## U.S. Department of Energy

25-TWO-0052

THE U.S. DEPARTMENT OF ENERGY, HANFORD FIELD OFFICE RESPONSE TO LETTER 25-NWP-028 FROM THE WASHINGTON STATE DEPARTMENT OF ECOLOGY AND TRANSMITTAL OF RPP-RPT-61684, "MAINTENANCE AND PERFORMANCE MONITORING PLAN FOR THE INTERIM SURFACE BARRIERS PROGRAM," REV. 5A

**Figure 4-1. T Tank Farm Interim Surface Barrier and Monitoring Nest Station Locations.**

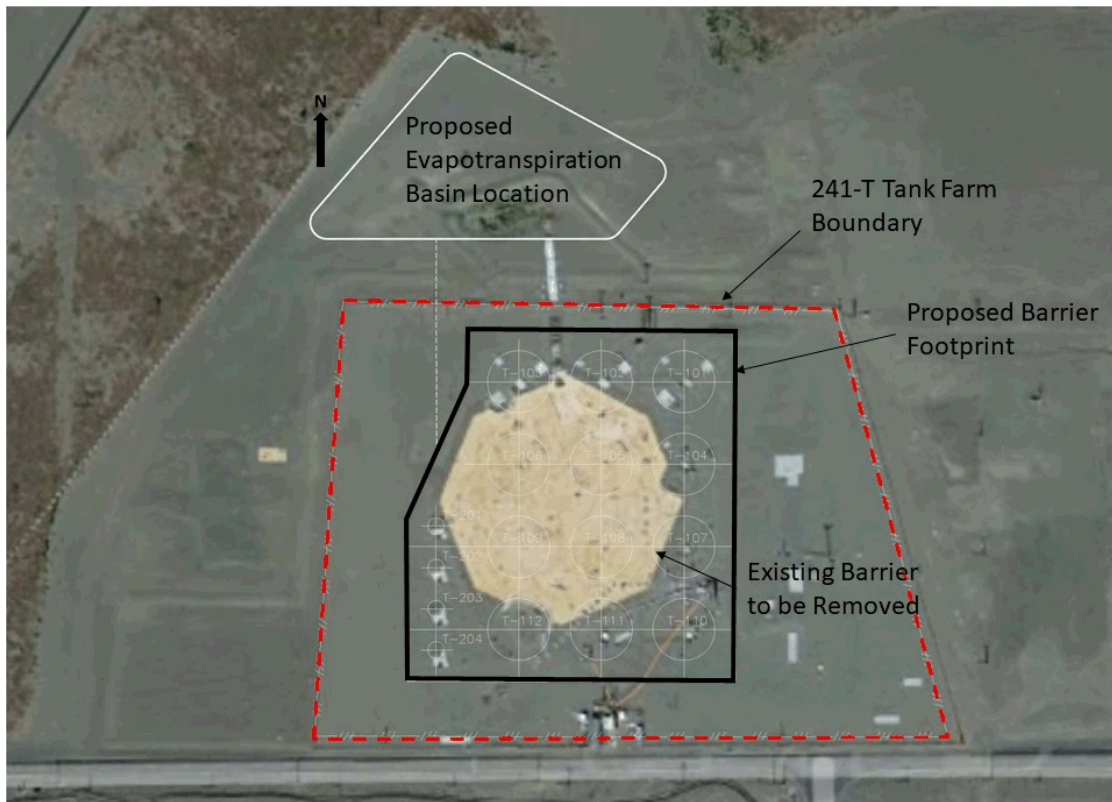
67.	24-TWO-0167 Attachment_5 RPP-RPT-61684, Rev. 4A	Figure 4-1 is from another document but does not include the figure description (e.g. explanation of the different monitoring instrumentation nests, footprint, edge effect, control point etc.) from the other document.	The figure should include a legend or description of the TA, TB, TC, and TD instrumentation nest equipment that is installed.	Clarification.	Not accepted. The purpose of the figure, which includes nest labels, is to identify locations not the type of equipment.				JR
